This is a new DP for an I-2 project on the east side of Clark and a few blocks north of E 1st Ave. Cody (PC) is sorting out some issues with the applicant, but I suspect drawings are being distributed. Could you please assign to one of the Metro Core planners? I'll be sure to pass on the drawings if I get them, and any info from the enquiry.

1290 CLARK DR

BC HYDRO SETBACK

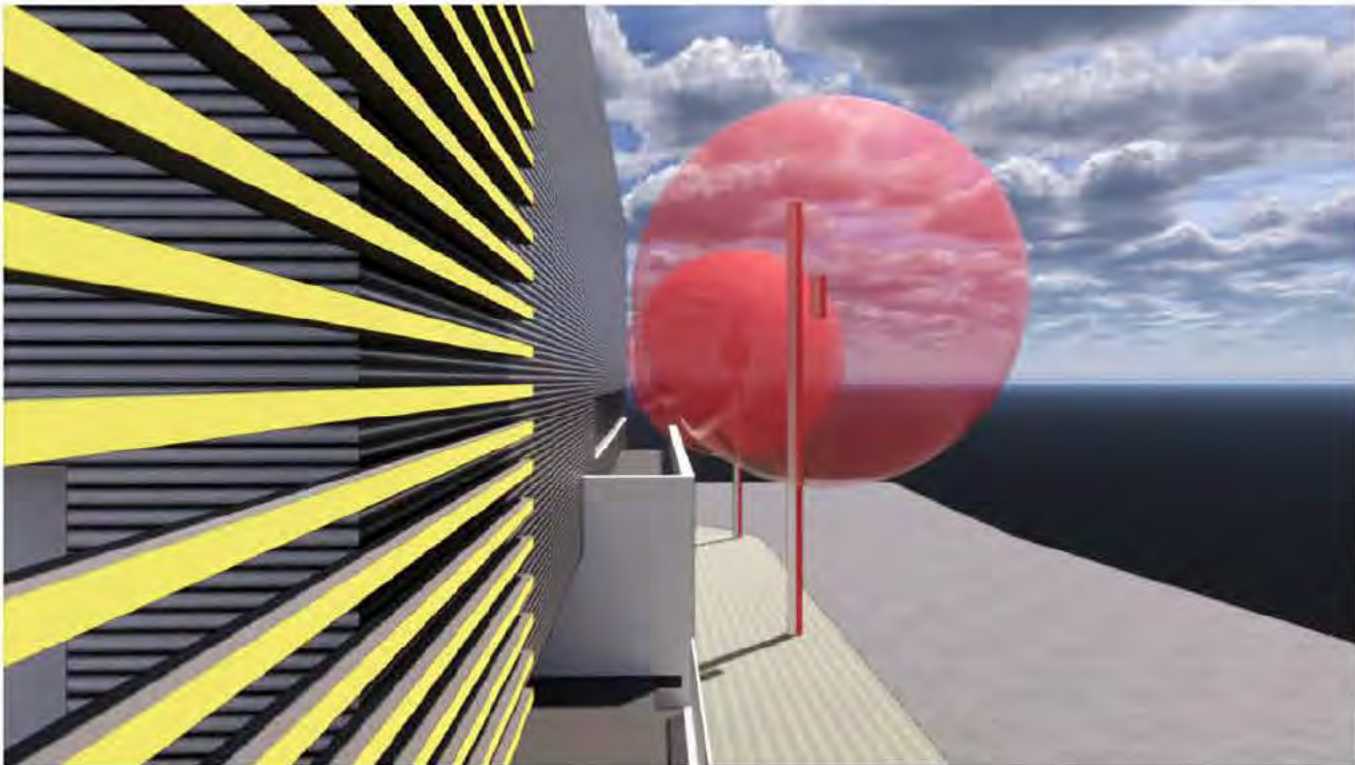
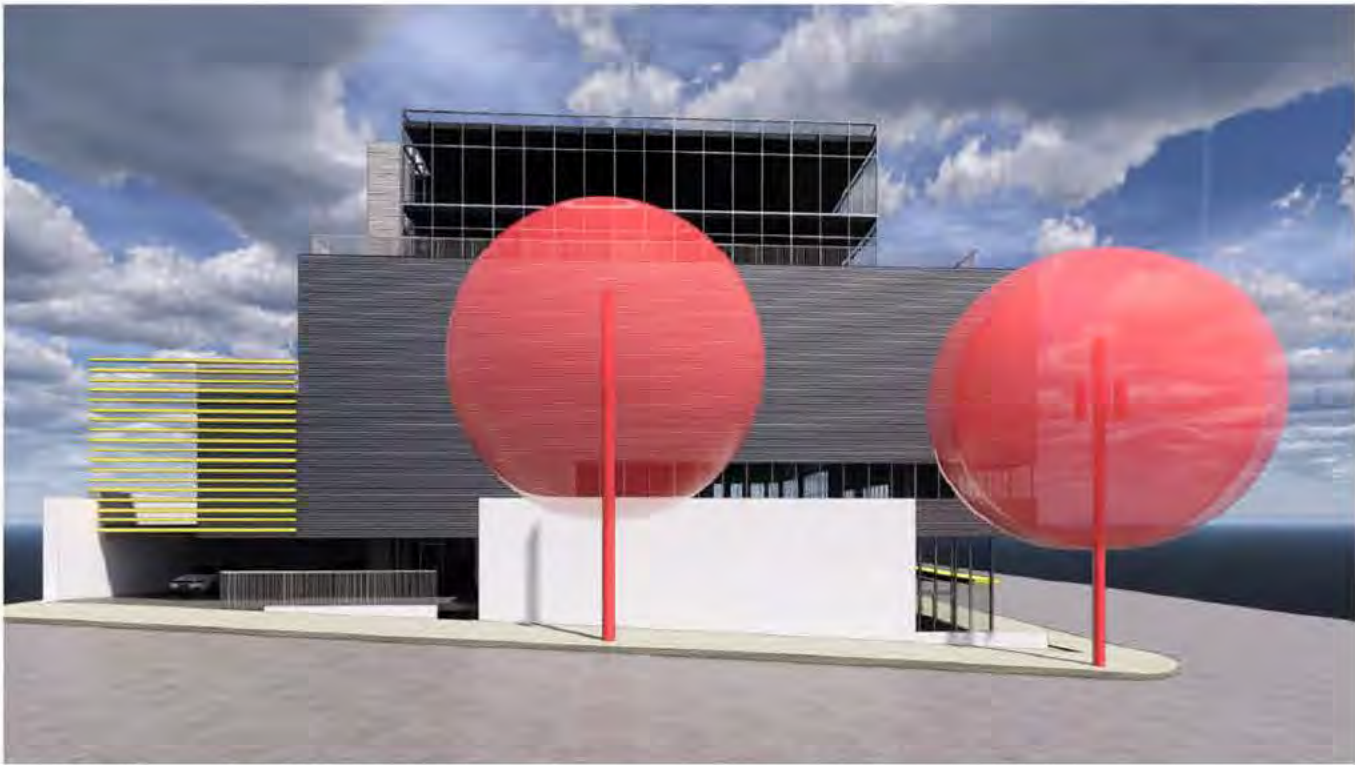
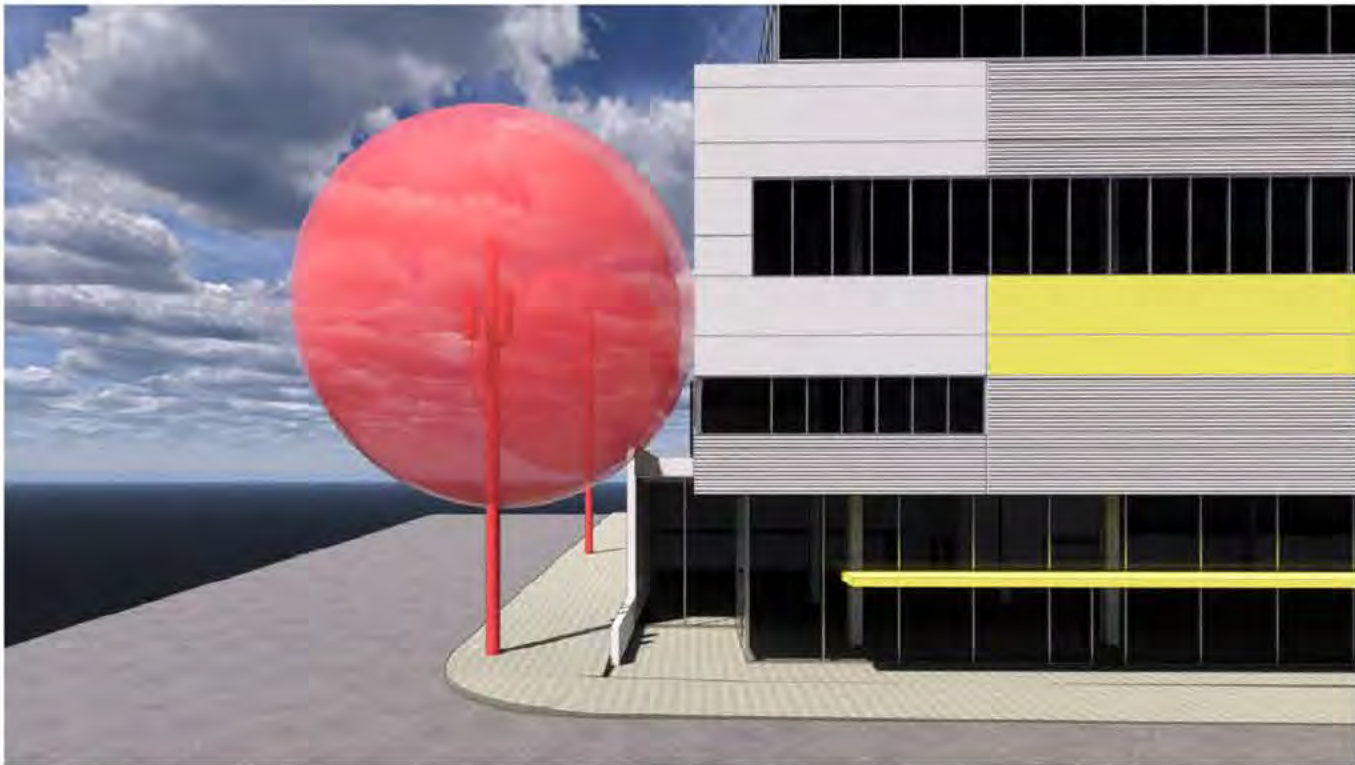
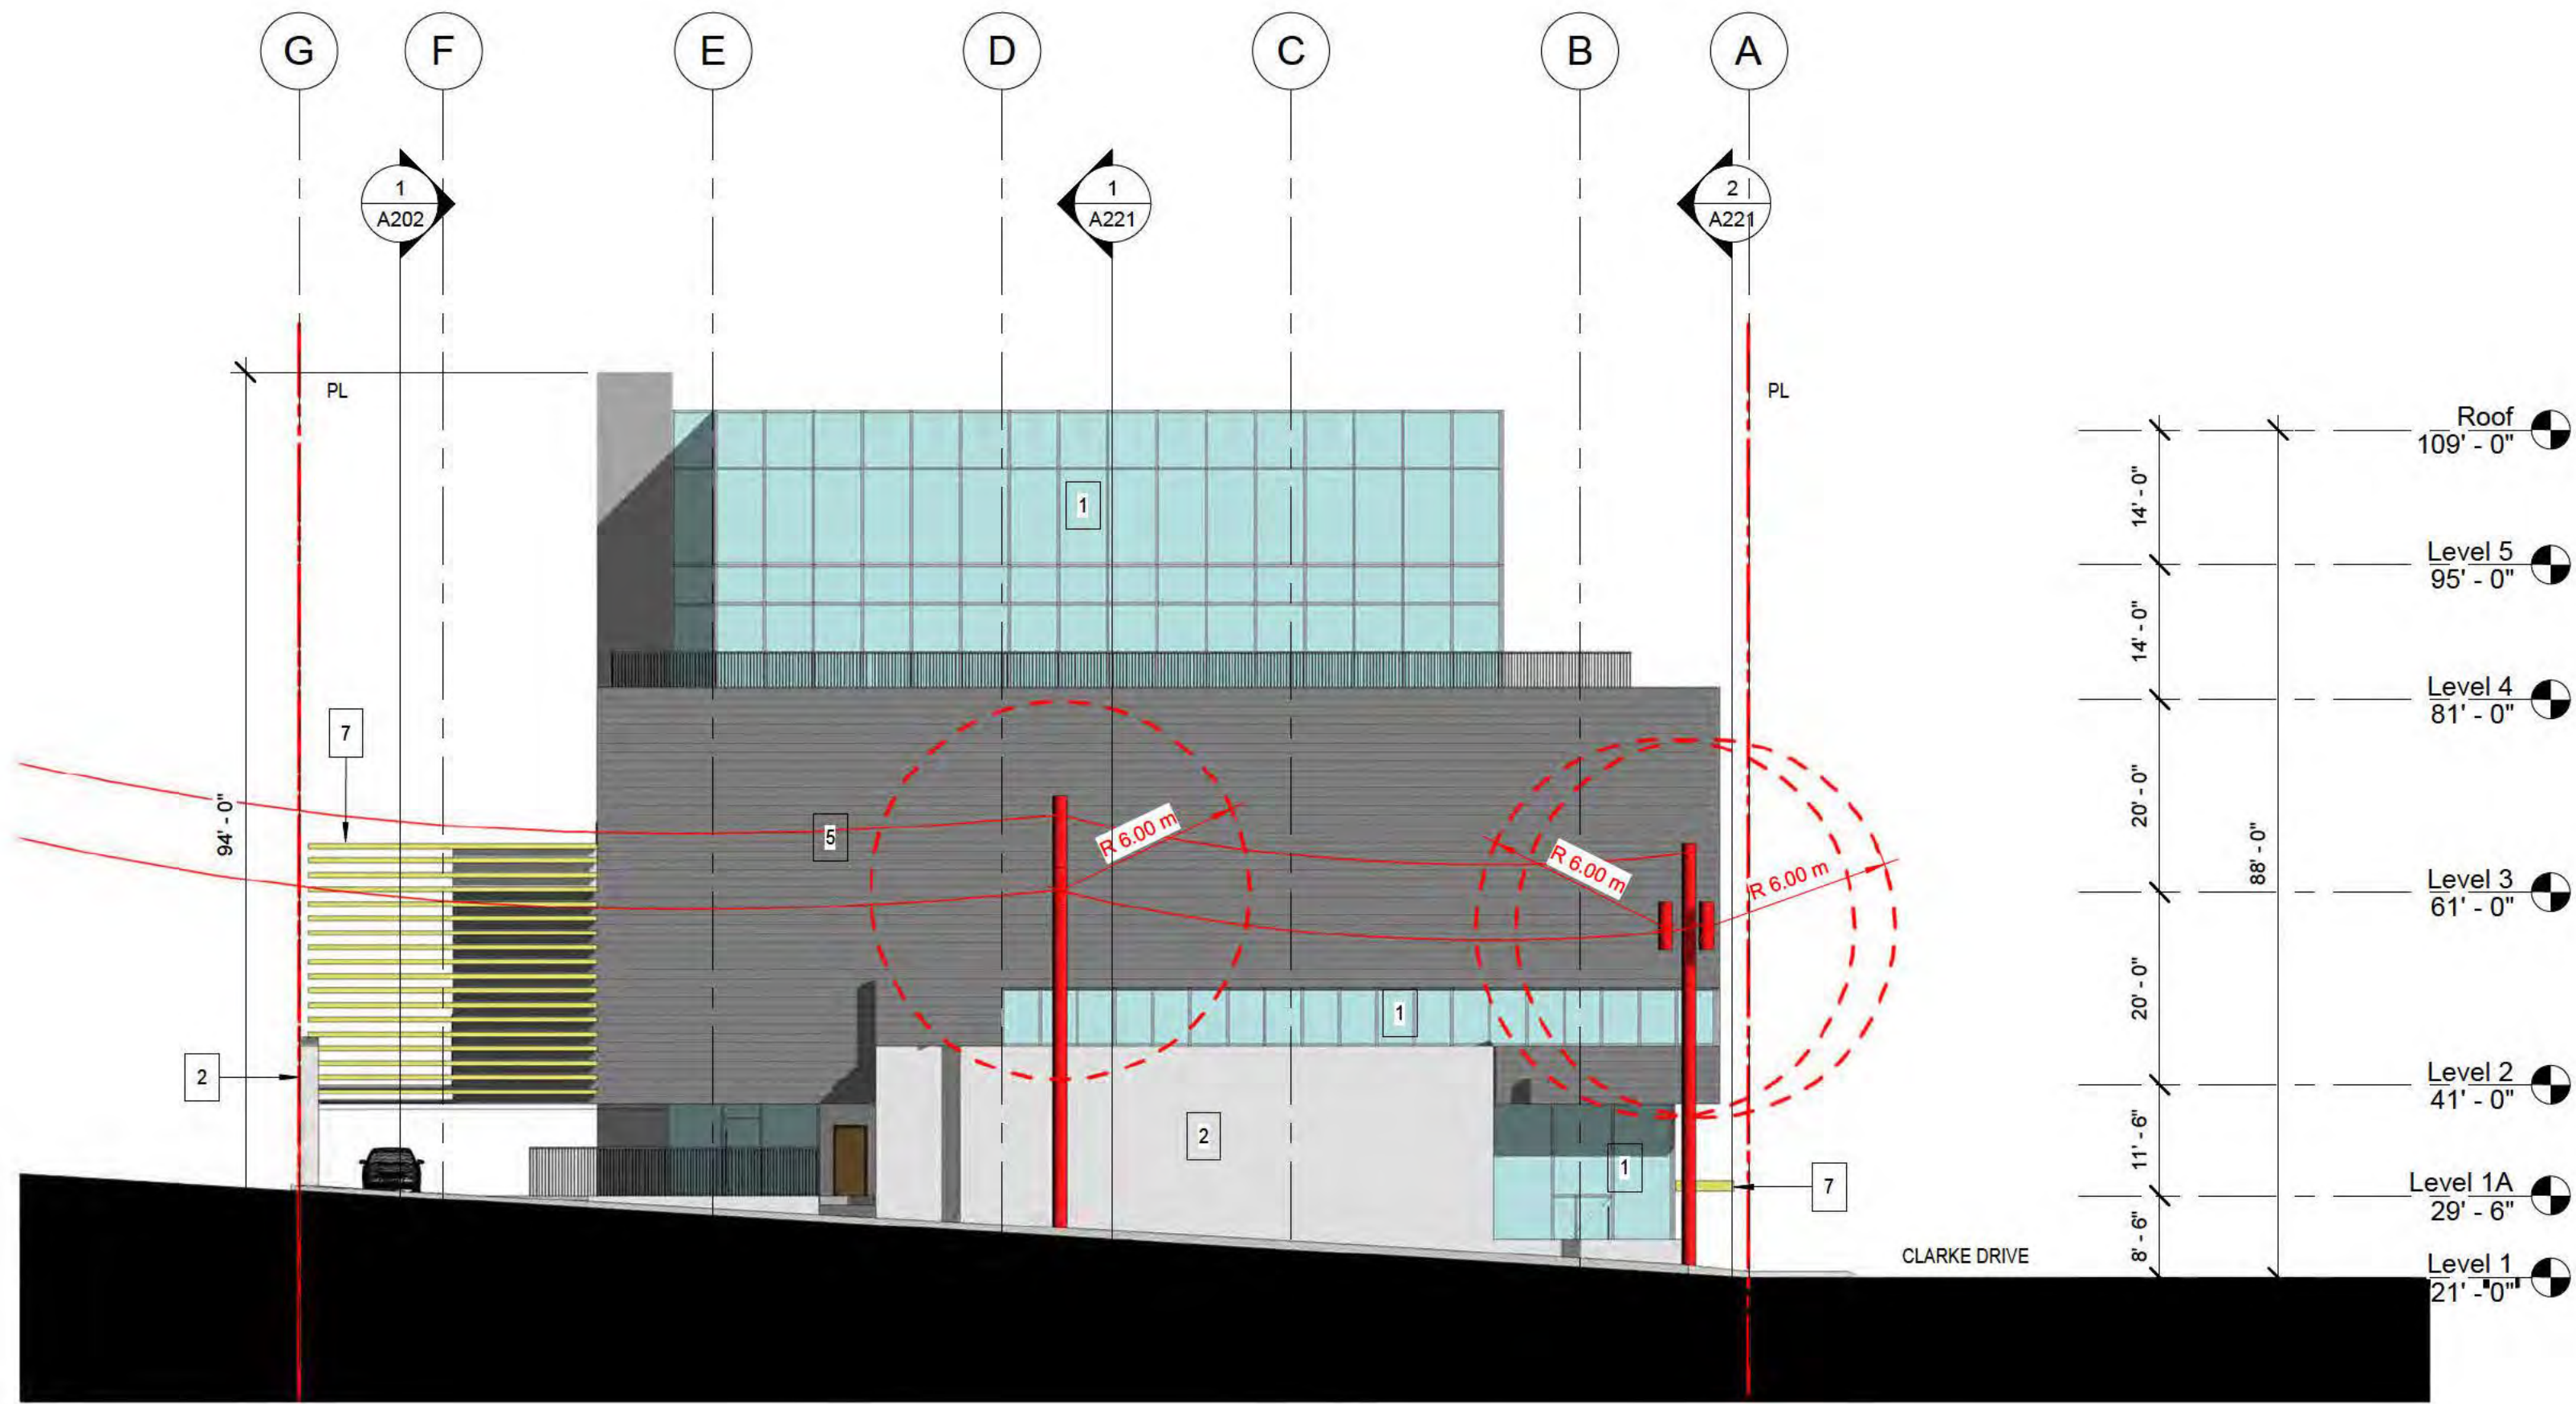
- NE site corner – pole is shown on plans, but survey not showing transformer
- NW site corner – triple transformer on single pole on survey, concern with proximity to building?

- HC Hydro Clearance Form not received, and noted that **existing poles/transformers not clearly noted or designed for clearance on plans**
 - NW site corner – triple transformer on single pole on survey, concern with proximity to building?
 - NE site corner – pole is shown on plans, but survey not showing transformer (not matching streetview?)

- HC Hydro Clearance Form noting clearance is met but proposing a balcony beneath the 6m sphere, and also see supplementary information requested showing existing poles/transformers to be clearly added to drawings with PTR revision with notes clearly explaining proposed condition:
- NW site corner – triple transformer on single pole on survey, concern with proximity to building?
- NE site corner – pole is shown on plans, but survey not showing transformer (not matching streetview?)

As per our discussions I will make amendments to the site plan and will include the correct survey as requested.
